Improved Design 430/440 Water Oscillator

The new design water oscillator assembly available for 430, 440, and Goss Community® style presses eliminates typical failures inherent to the old screw in oscillator design. This design has been used on all 430 and 440 units since mid-2006.

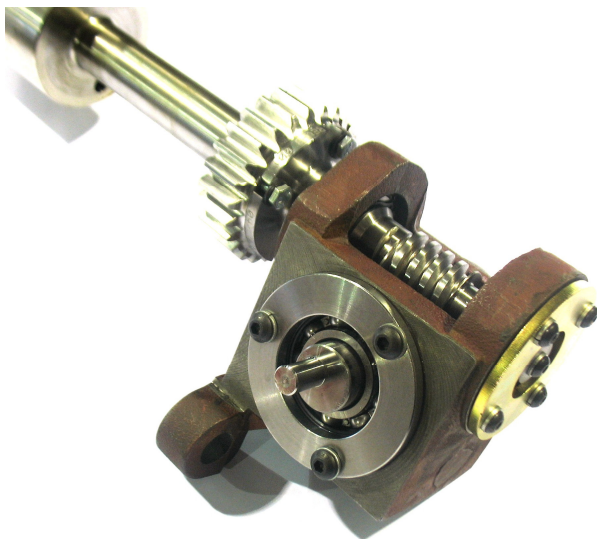
- Water oscillator roller is the same for 10&13 sides which means less spares required on hand.
- Roller spur gear mounted directly on roller shaft, not on the worm gear shaft as on old design. This gives less gear run out for longer gear life.
- Oscillator housing is rigidly supported by a locating diameter and four wide spaced bolts. Eliminates oscillator box “wobble” common on the old thread together design.
- Bolt together design will not loosen if your press is equipped with reverse. No pinning required for reverse as on old design.
